UPDATE REPORT

**FOR DEVELOPMENT CONTROL COMMITTEE
MEETING OF 23 FEBRUARY 2021**

Item B1 2020/0363 Proposed Foodstore, Henrietta Street, Bacup

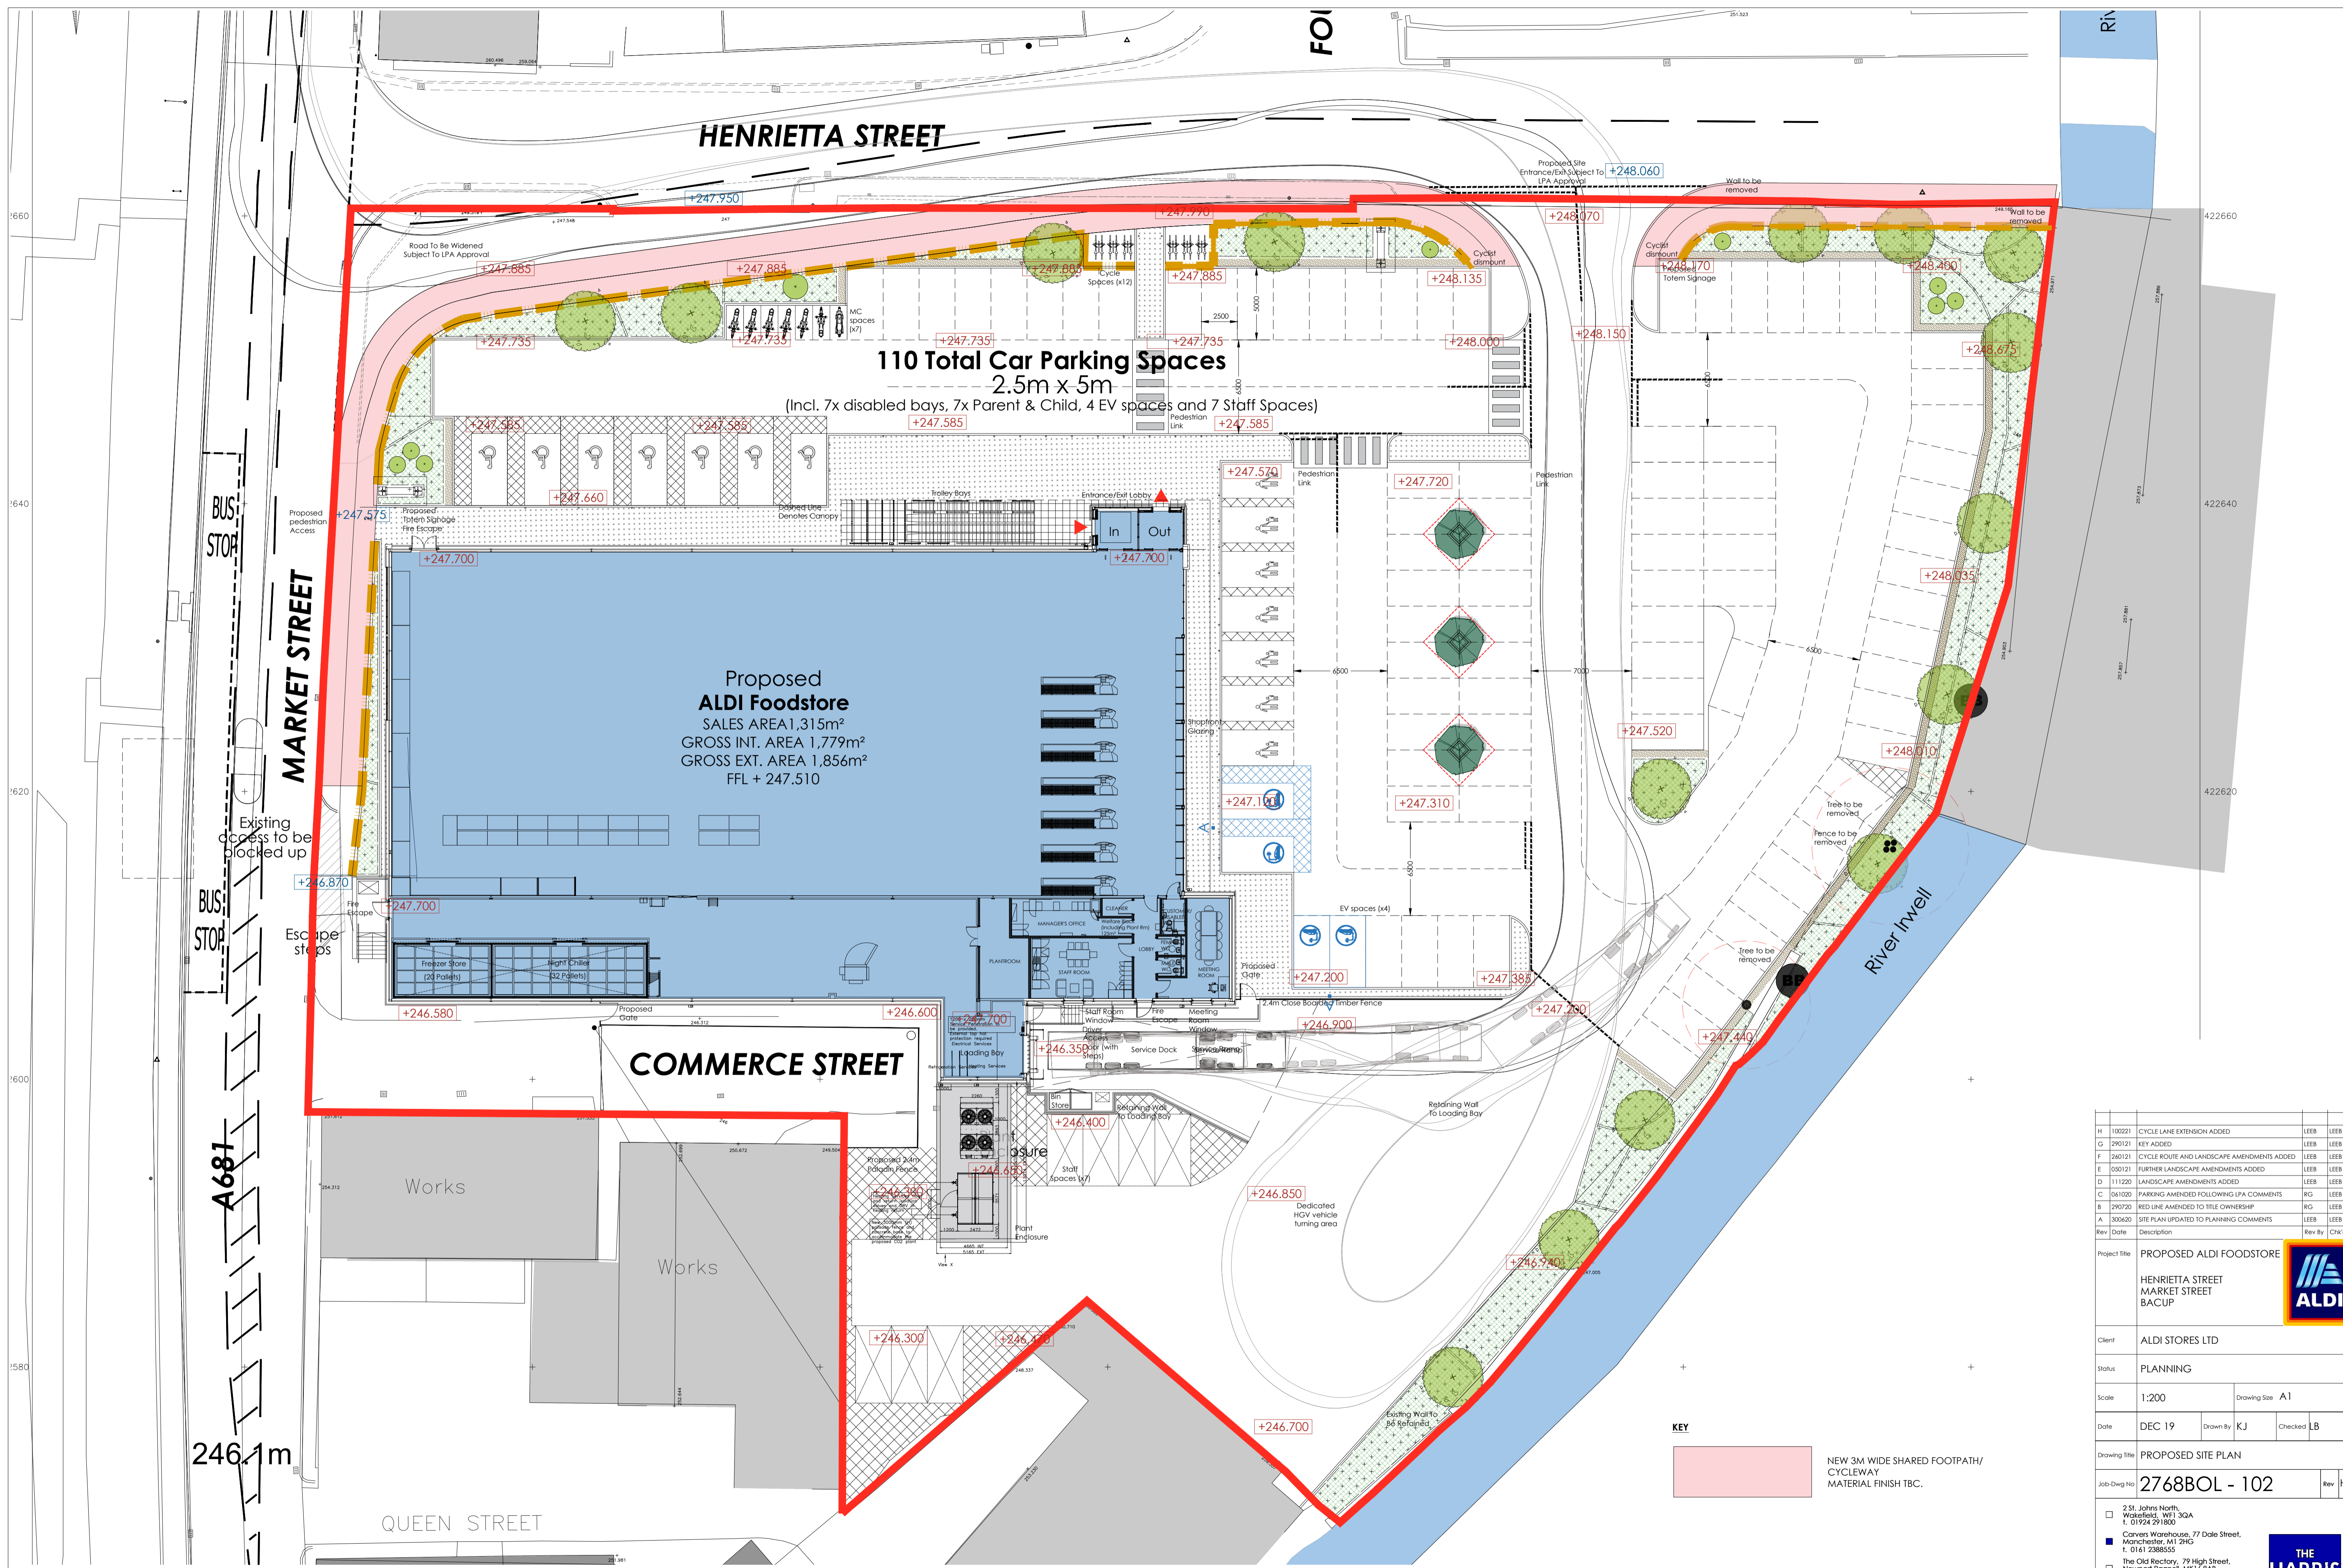
One specific concern expressed is in relation to the width of the footway on Market Street, on the northern corner of Henrietta Street – that it is too narrow, rendering it unsafe. LCC Highways have responded on this point as follows:

“The alterations to the Henrietta Street / Market Street junction will be subject to a full safety audit process as part of the s278 scheme approval process and any issues regarding visibility, pedestrian facilities will be addressed. It should however be borne in mind that the junction in its current form serves 2 existing users (Morrisons’ deliveries and an LCC highways depot). There are no recorded injury accidents at this junction and any improvement would provide betterment to the existing situation.”
